CITY PLANNING COMMISSION

APPLICATION: A. Negative Declaration
B. Plan Review for a 216-unit apartment complex (Sec. 13-3-C(4))

LOCATION: South side of Brookfield, west of Franklin Boulevard at Valley Wind Way

APPLC. NO. P85-025

site plan

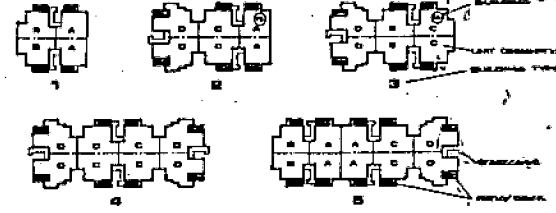
- B. The site plan indicates that a minimum 25-foot landscaped setback will be provided along all public street frontages. Additional setbacks and landscaping have been provided along Franklin Boulevard to accommodate the realignment and modification of Franklin Boulevard at the Florin Creek bridge.

In addition, to discourage parking on the street as well as screening the on site parking areas from public view, additional screening shrubs should be planted along the perimeter of the project.

- 1. The applicant shall adhere to the setbacks indicated in the attached site plan.
- 2. Applicant shall finish stair stringers with a color that is compatible with the exterior wood. Railing shall consist of wood over metal;
- 3. Plans for carports shall be submitted for Planning Director review prior to issuance of a building permit. The design and material of the carports shall be compatible in material and design of the main structure on the site.
- 4. The applicant shall adhere to the attached Multiple Family Residential Design Criteria in Exhibit A.

5. The applicant shall provide additional shrubs planting along the perimeter of the project. The landscape plan indicating this condition shall be submitted to the Planning Director for review and approval.
6. The applicant shall expand the recreation structure to adequately serve the project. The design of this structure shall be compatible in materials and colors with the apartment structures. Final elevations and floor plans shall be reviewed and approved by the Planning Director.

architectural plans
SUNMEADOW APARTMENTS

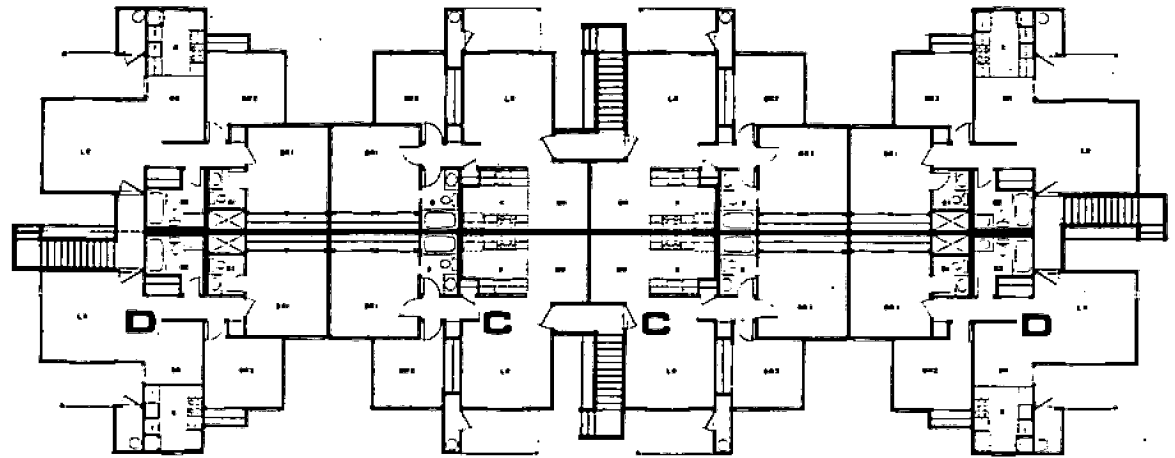
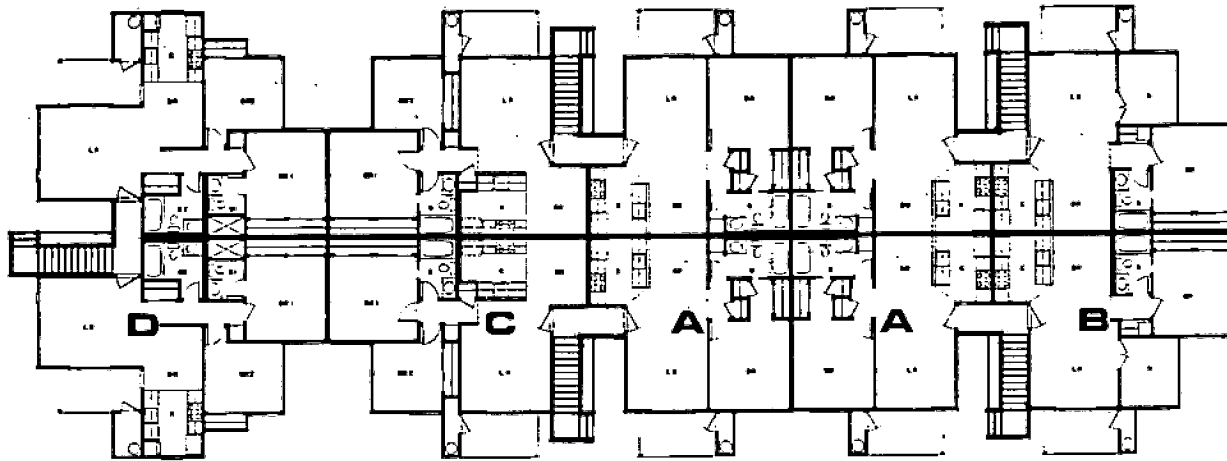
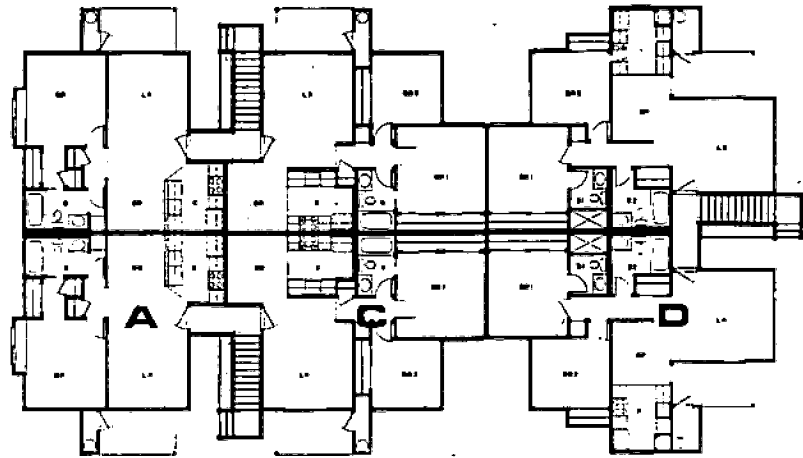
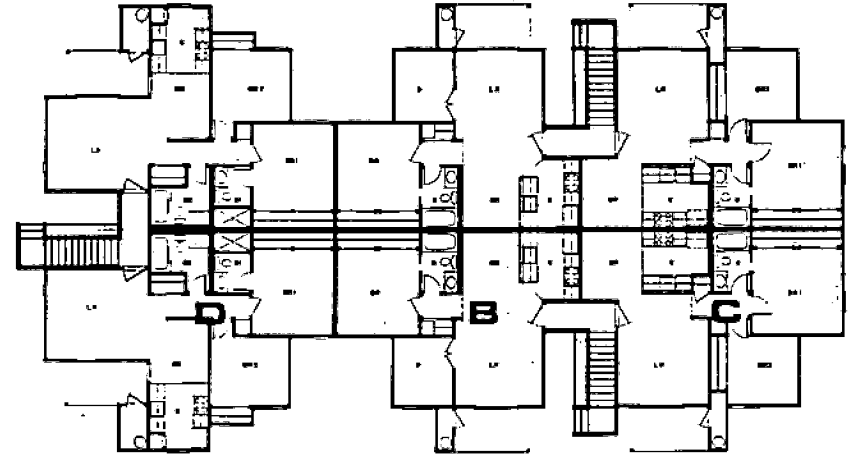
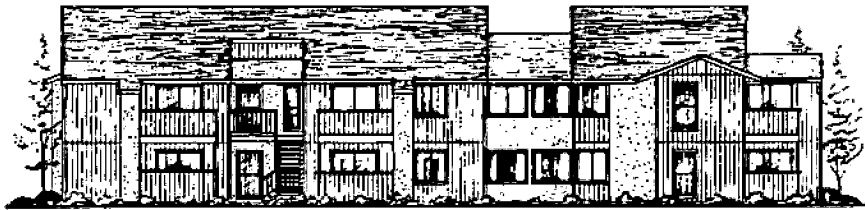
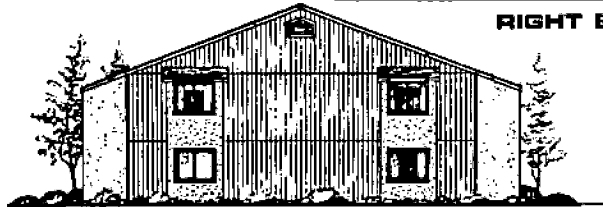
- D. As proposed, the structures consist of two-story buildings finished in R-111 siding with composition roofs. Minimal relief has been provided to the elevations by the use of stucco in the entry way and on the storage walls. In an effort to improve the exterior elevations staff recommends the following modifications:

Also, additional stucco is utilized to reduce the abundance of the T-111 wood siding. However, staff suggests the applicant finish the stair stringers with a color that is compatible with the exterior wood siding. Also, stair railing should consist of wood over metal. The applicant should also consider screening the stairs with a trellis element or a stucco wing wall element.

1. On all end elevations more movement of wall plane and change in surface detailing is needed to provide relief.
 2. The overhang on all shed roofs shall be extended.

3. Provide additional overhang on the gable ends of the buildings.
 4. Utilize horizontal wood siding on some buildings or reduce the percentage of T-111 by providing additional stucco over what is proposed. (A change in material should only occur with a change of surface plane.)

5. Utilize two stringers on the entry stairs. Railing and balusters should consist of wood or wood over metal.
 6. No elevations were provided for the carports. The carports shall be compatible in design and material with the apartment structures.

1. The applicant shall adhere to the setbacks indicated in the attached site plan.
2. The buiding elevations and material shall be modified as follows:
 - a. On all end elevations more movement of wall plane and change in surface detailing is needed to provide relief;
 - b. The overhang on all shed roofs shall be extended;
 - c. Provide additional overhang on the gable ends of the buildings.
 - d. Utilize horizontal wood siding or reduce the percentage of T-111 by providing additional stuccoed siding. (A change in material should only occur with a change of surface plane.)
